SERVICE BULLETIN

DATE: 8 DECEMBER 1978

INSPECTION AND REWORK OF TAIL ROTOR HUB, PN 369A1725-5 AND 369A1725-501; INSPECTION OF TAIL ROTOR BLADE ATTACHMENT BOLTS; PN MS21250-06040

Figure 1. Rework of Tail Rotor Hub Assembly

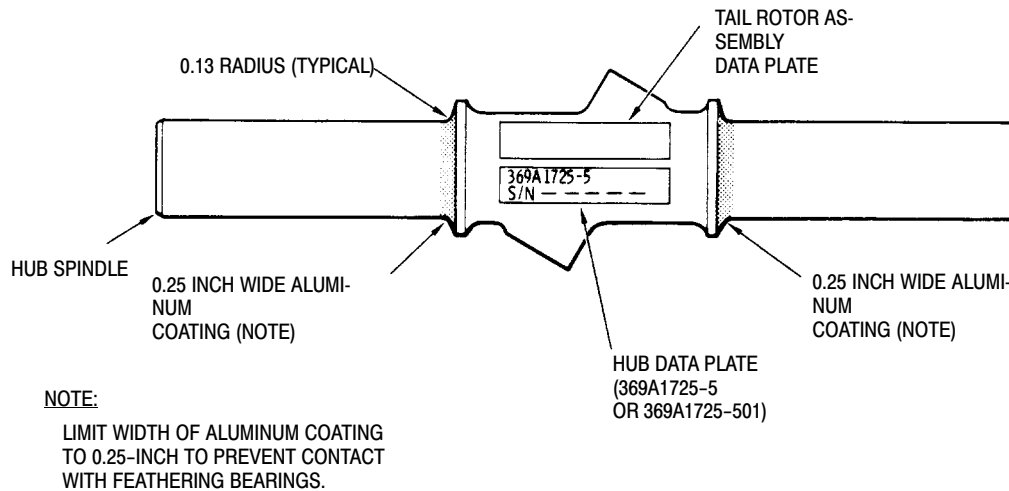
- (2). Clean hub with MEK.
- (3). Using 10X glass, inspect hub for cracks and corrosion or other damage. Pay particular attention to area of 0.13 radii between the spindles and center portion of the hub. (See Figure 1.)

- (b). If corrosion or pitting is noted, clean hub surface with fine emery cloth or crocus cloth.
 - (c). If surface repair was performed in a. or b. above, clean hub with MEK and reinspect hub with 10X glass. Pay particular attention to 0.13 radius areas on both sides of the hub.

- (d). If hub is rejected, contact HH Customer Service Department for disposition.
- (4). Magnetic particle inspect hub for cracks, per MIL-I-6868. Pay particular attention to 0.13 radius areas on both sides of the hub. If hub is rejected, contact HH Customer Service Department for disposition.

- (5). Rework hub as follows using Alumazite Z:
 - (a). Shake contents of container thoroughly.
 - (b). Brush a thin (0. 0002 to 0. 0005 inch) even coat onto cleaned surface of 0.13 radius areas on both sides of the hub. (See Figure 1.) Limit width of aluminum coating to 0.25 inch, to prevent contact with feathering bearings.

- (6). Add letter “Z” following serial number on hub data plate, to denote rework of 369A1725-5 or 369A1725-501 hub. (See Figure 1.)
